ADDENDUM No. Four (4)

IFB No. 2021-239

CONSTRUCTION, COLLIN COUNTY ADULT DETENTION FACILITY, PHASE 1 ADDITION

DATE: AUGUST 20, 2021

21913
7/13/2021
E211

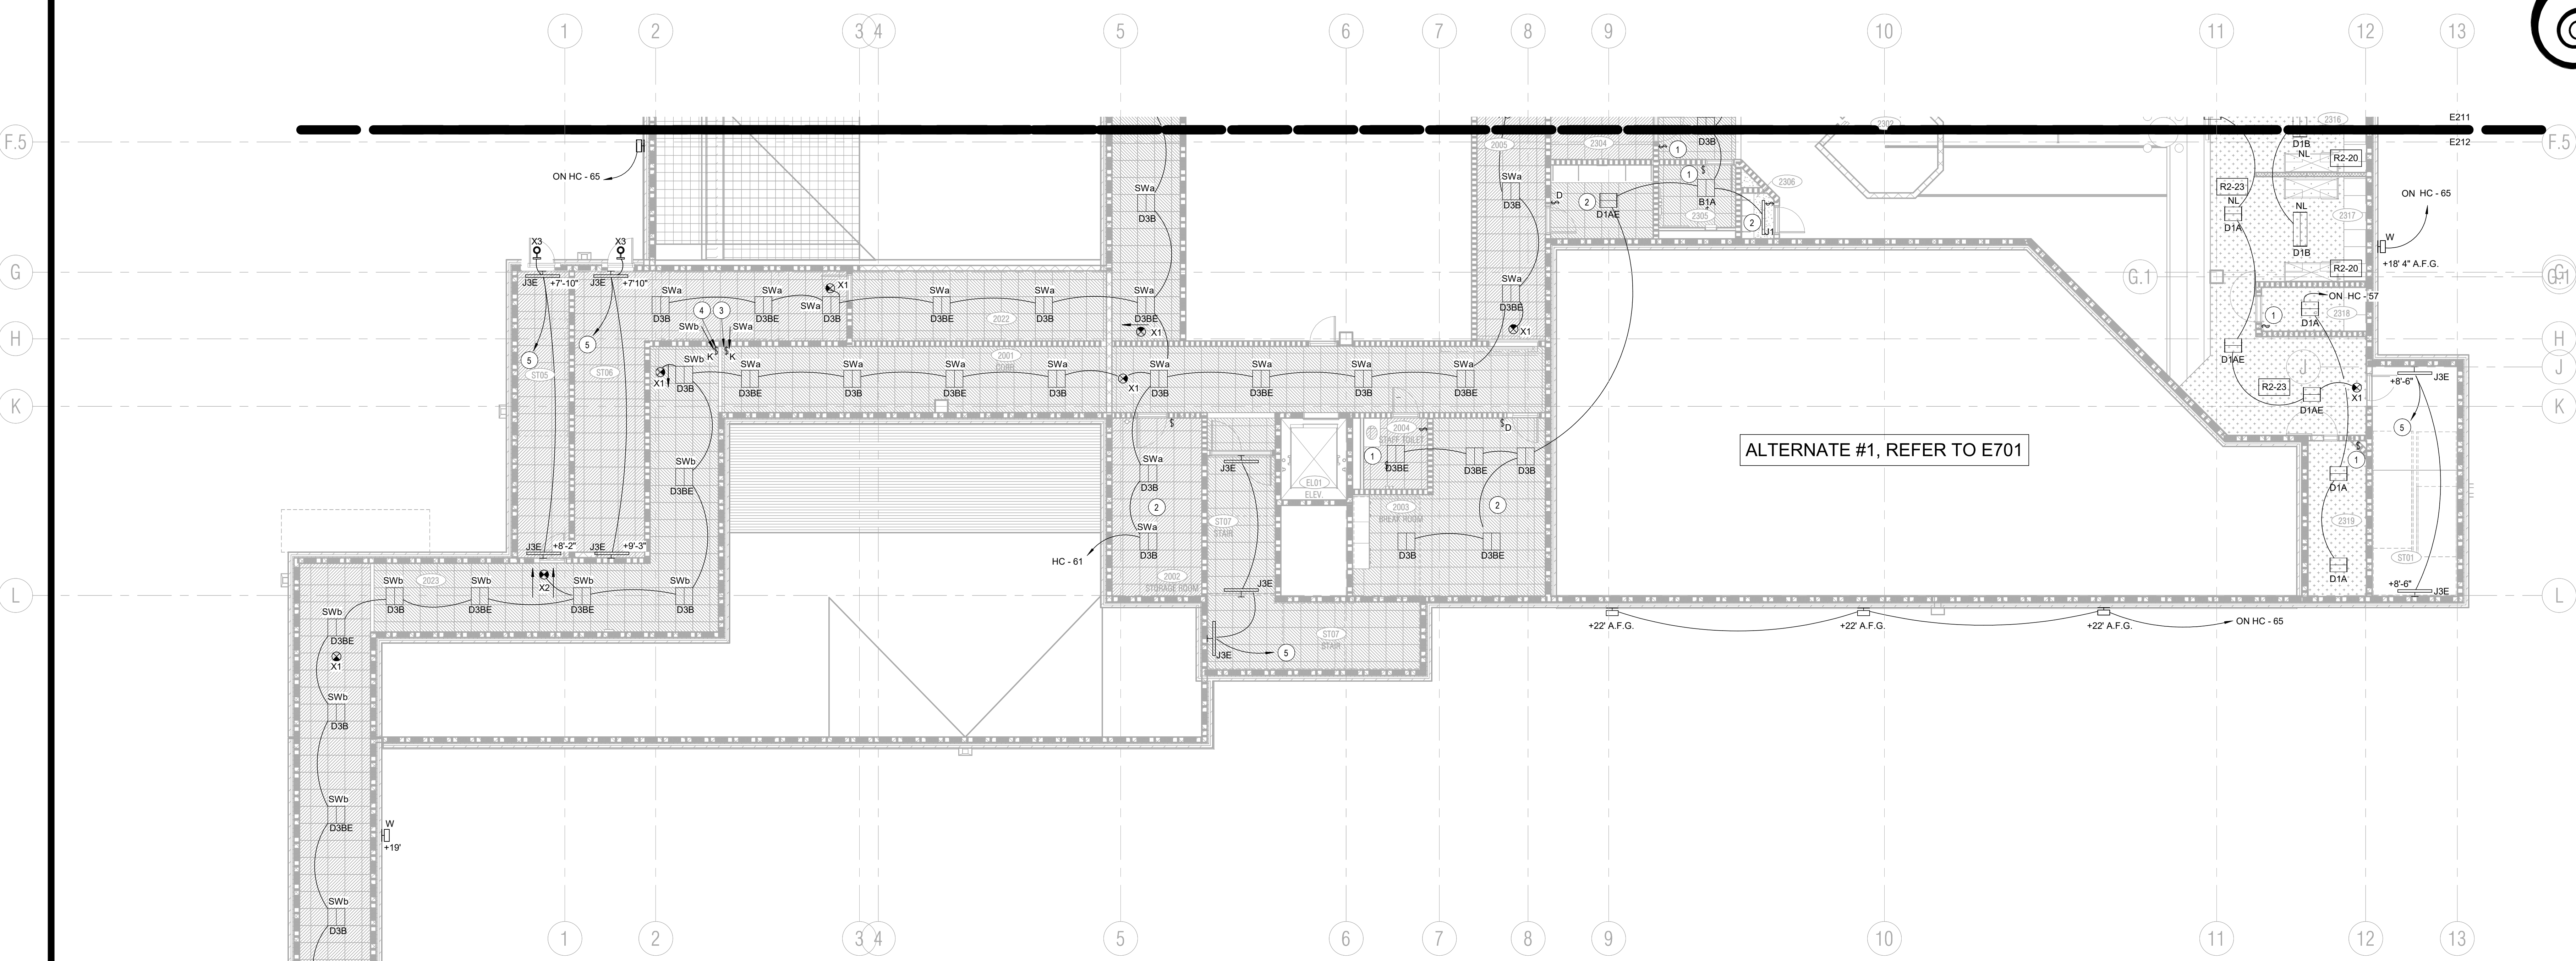
A. MDE Revision: General note added.
- Item No. 63. Sheet – E221**
A. MDE Revision: Moved light fixture in mechanical room corridor to wall.
- Item No. 64. Sheet – E302**

21913
07/13/2021
FP203

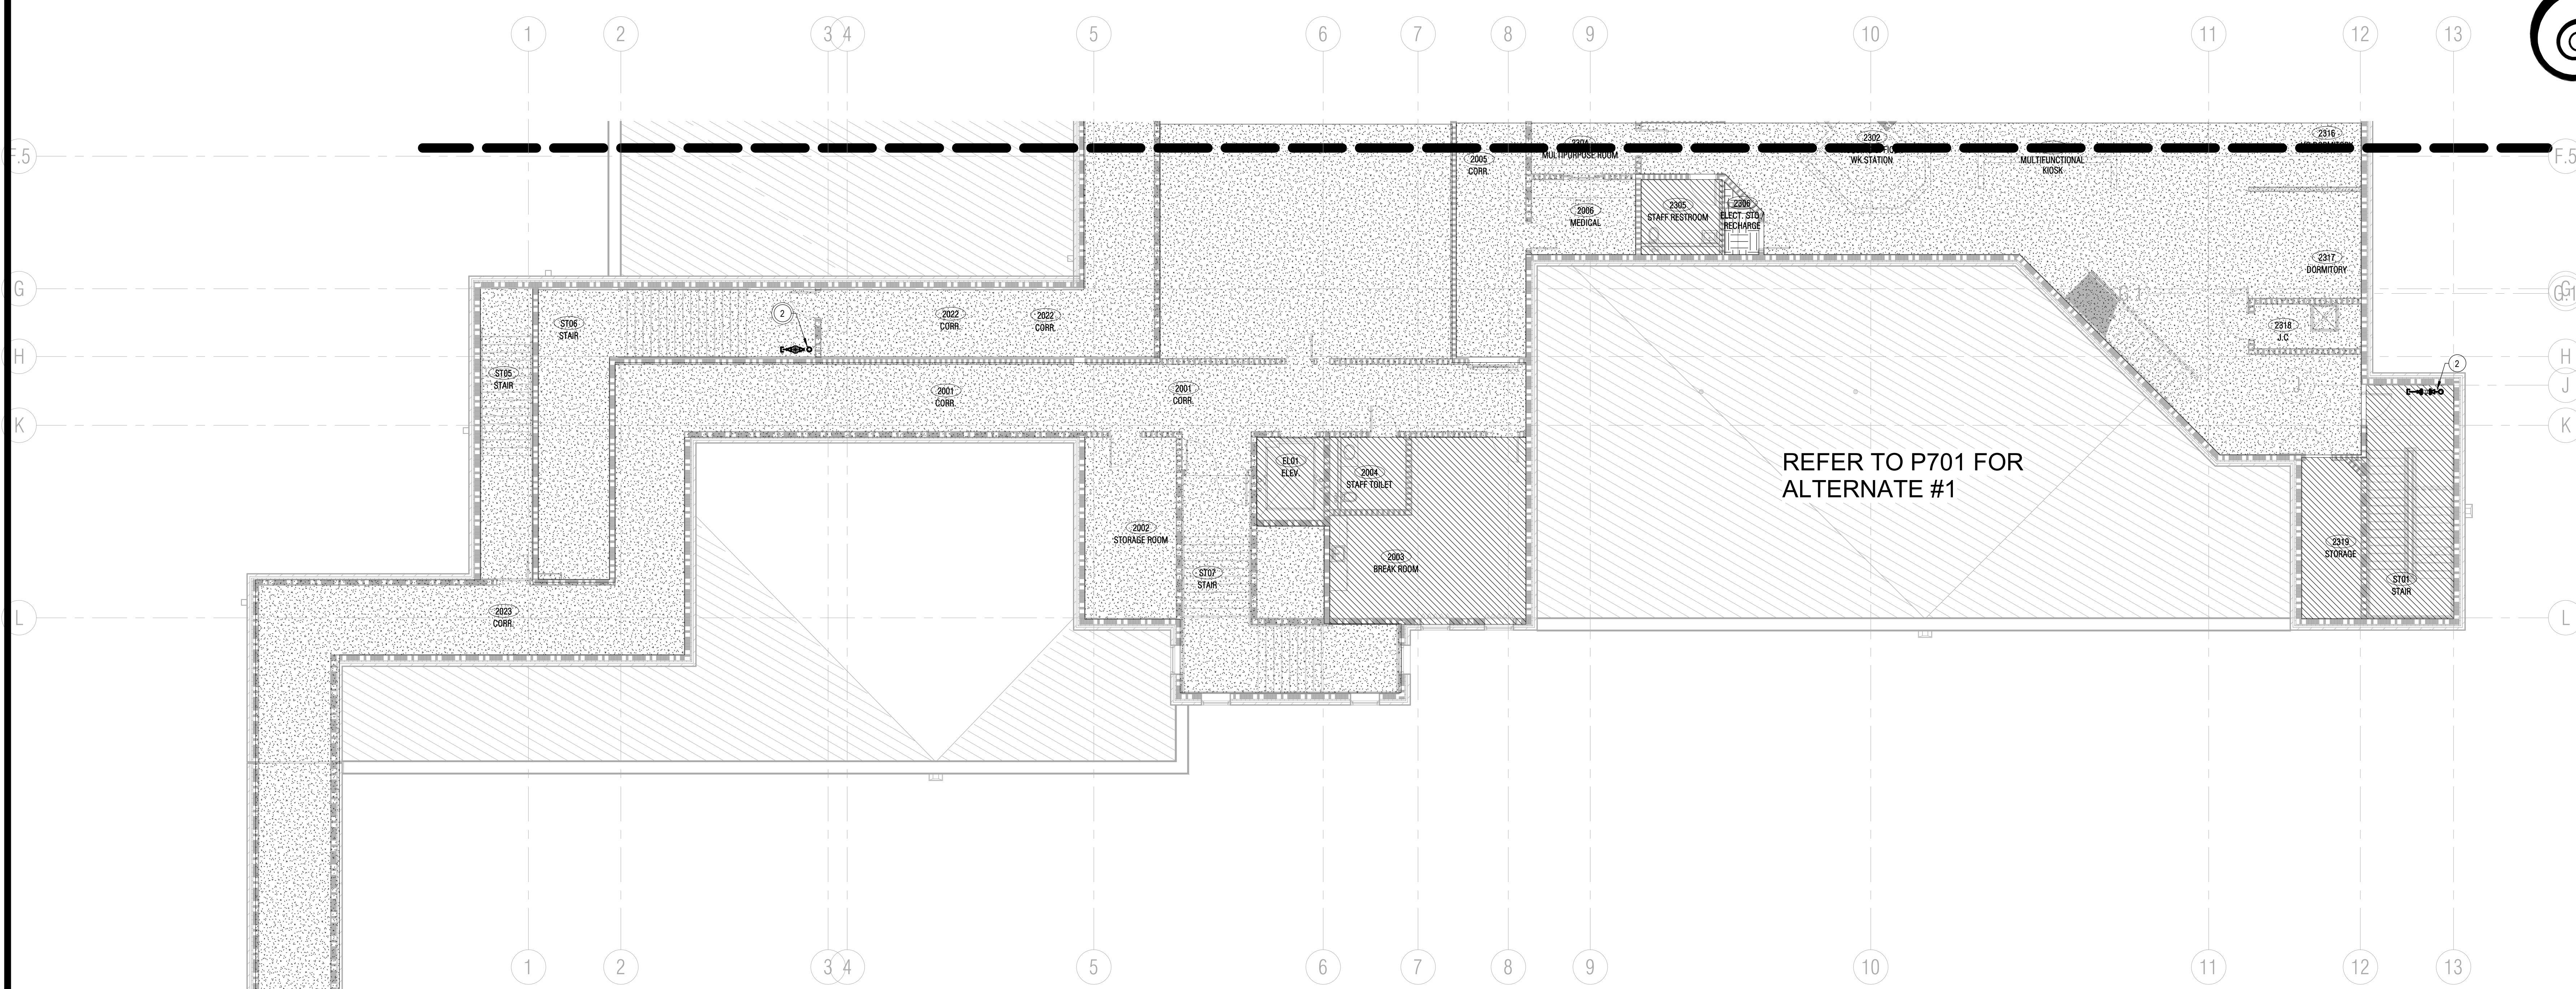
- A. MDE Revision: added fire protection standard note from city comments
- Item No. 56. Sheet – P003**
- A. MDE Revision: revised WS-1 water softener model and revised main water pipe size on water demand schedule from 3” to new 4”

01 SMOKE REMOVAL SCHEMATIC - CELLS / DAYROOM SCALE: NTS

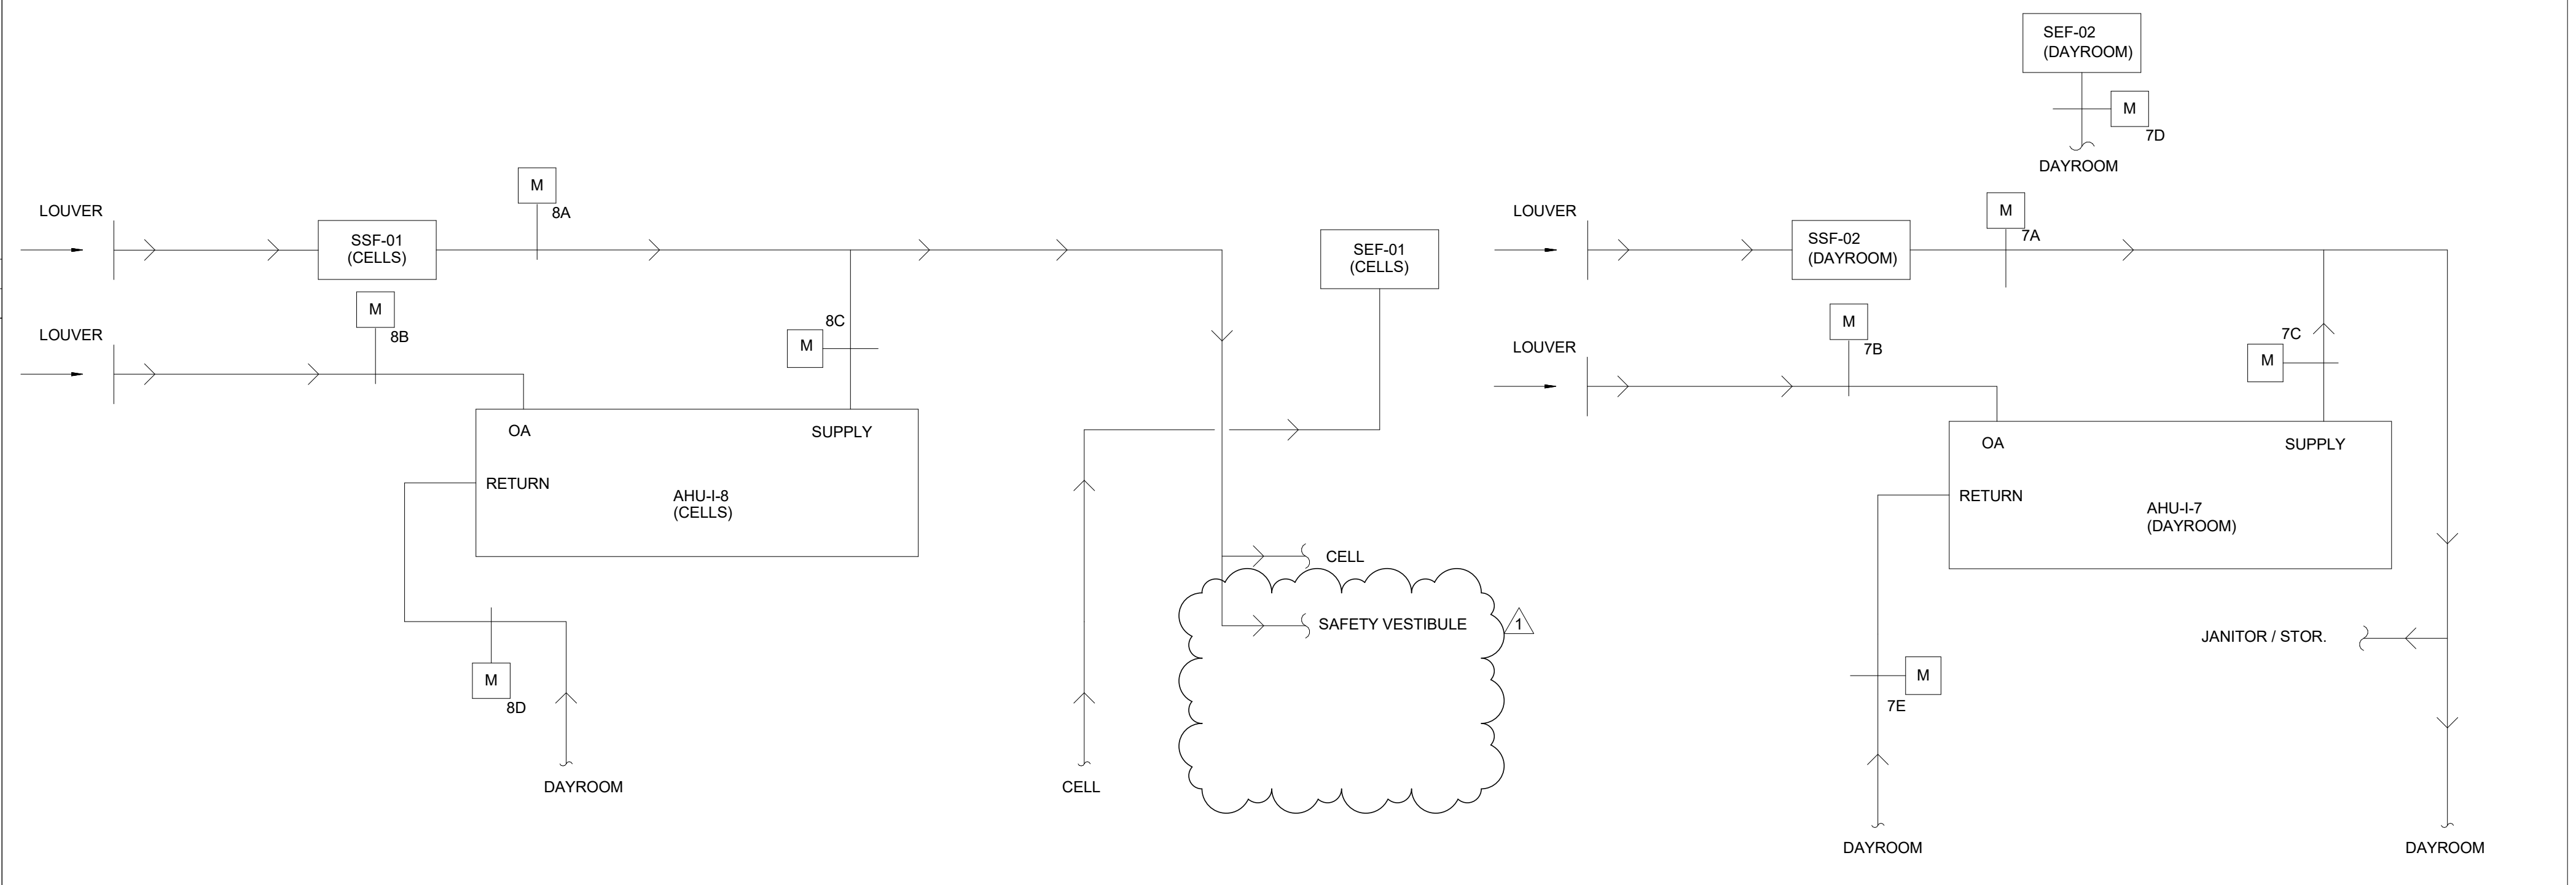
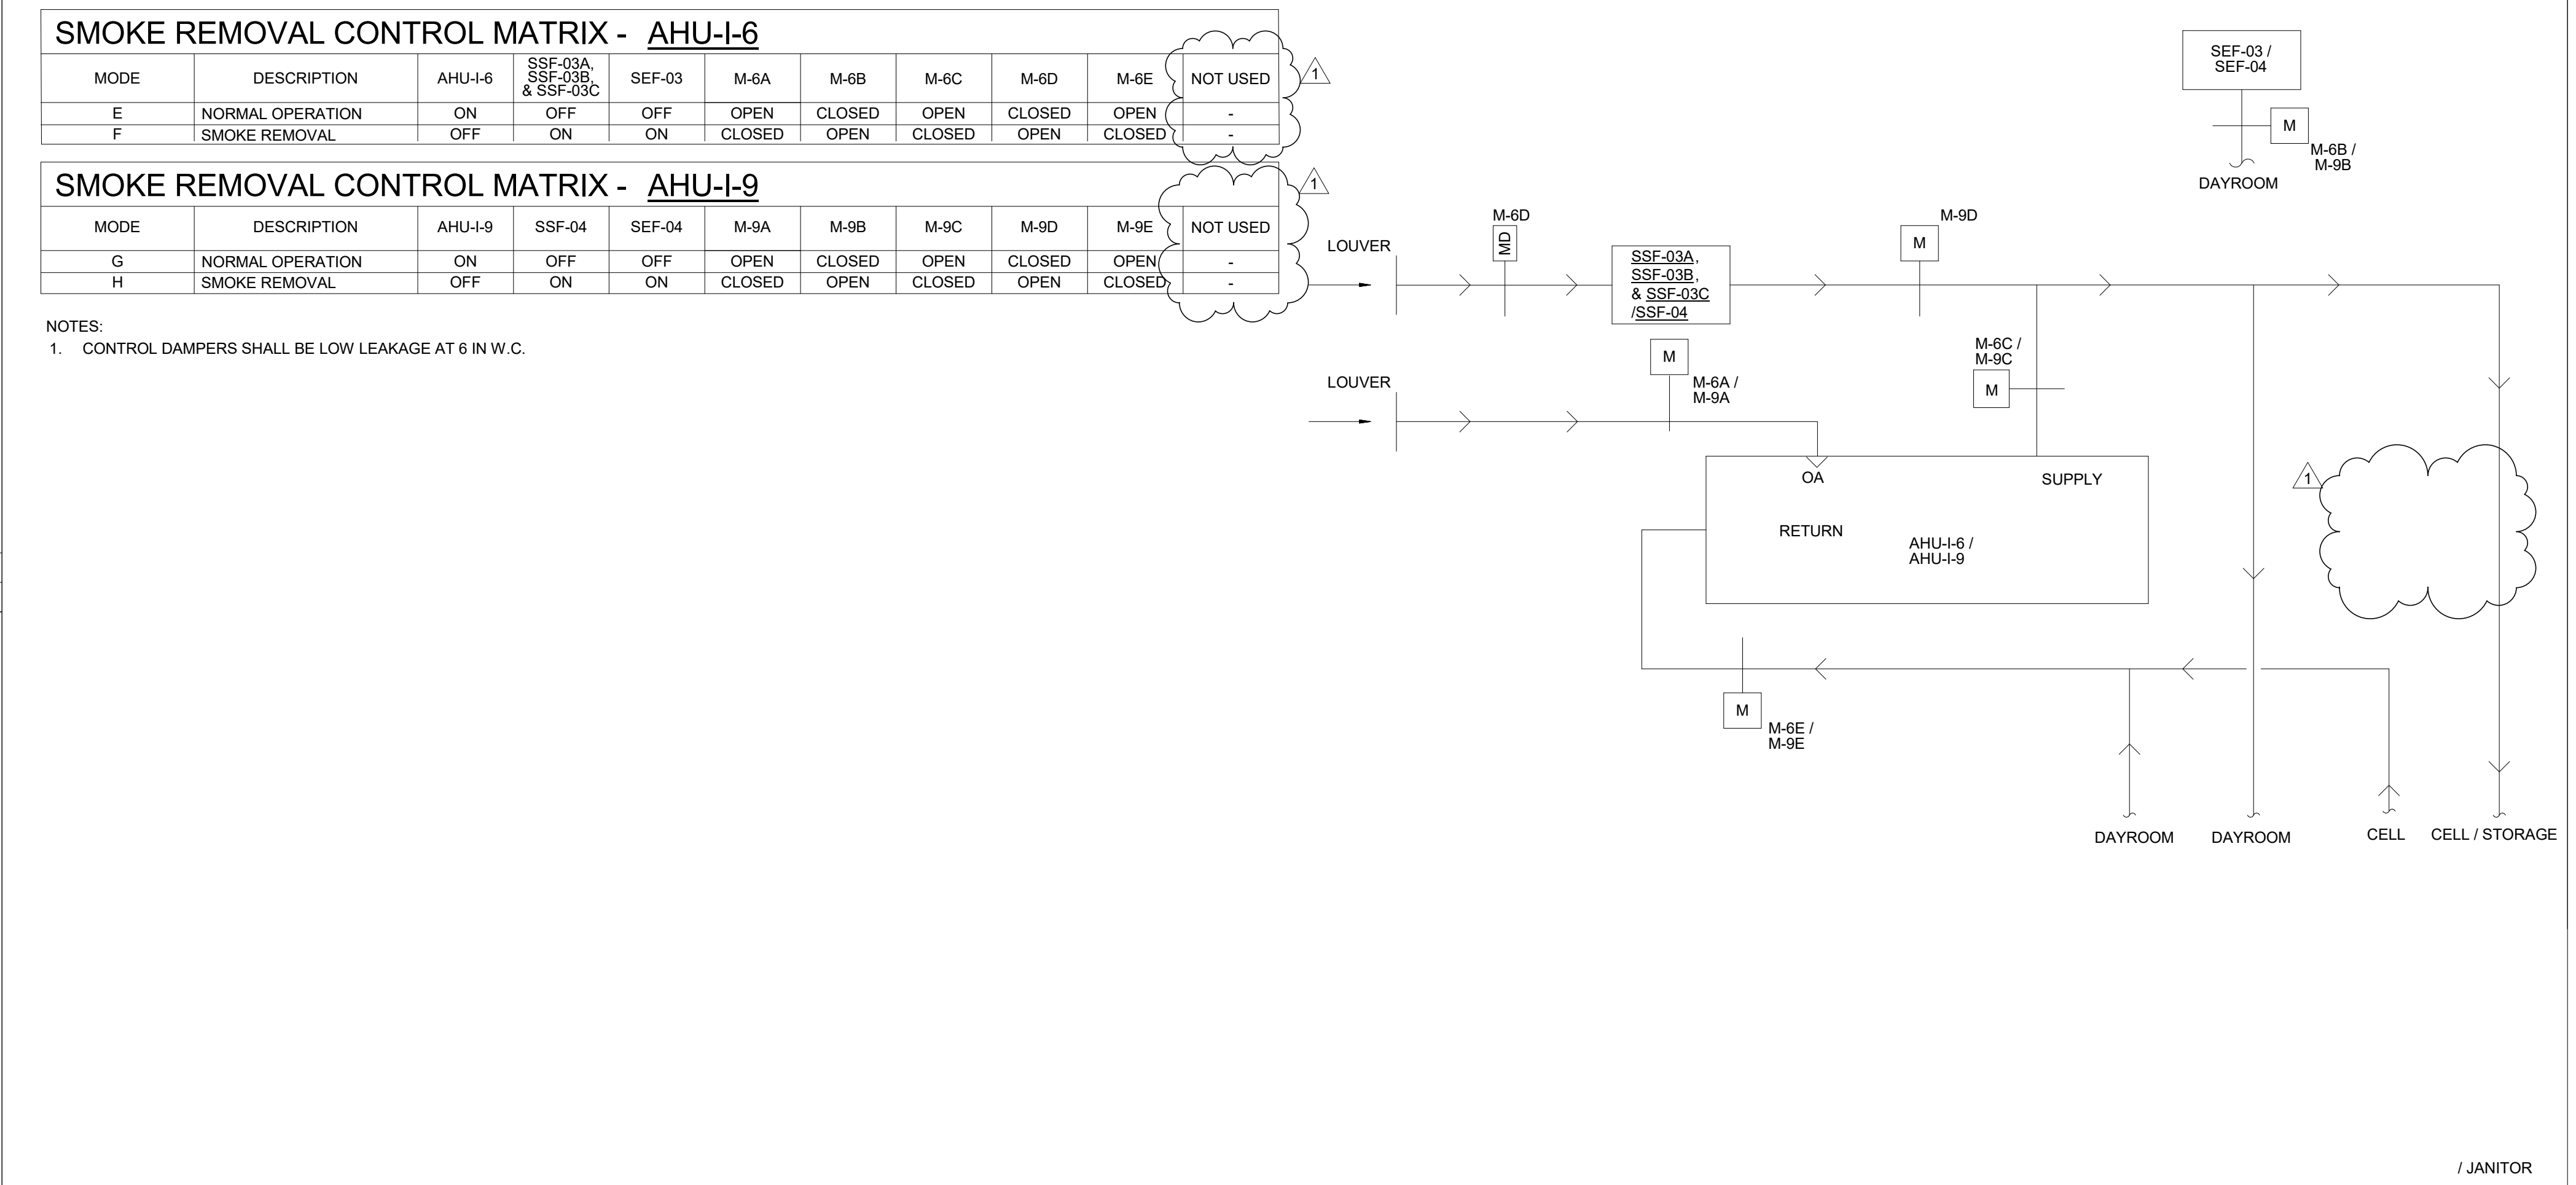
- Item No. 46. Sheet – M302**
- A. MDE Revision: Added UH-18 & associated hydronic piping.
- Item No. 47. Sheet – M403**
- A. MDE Revision: Revised Smoke Removal Schematic and Matrix for removal of motorized damper M-6F, M-8E, & M-9F.
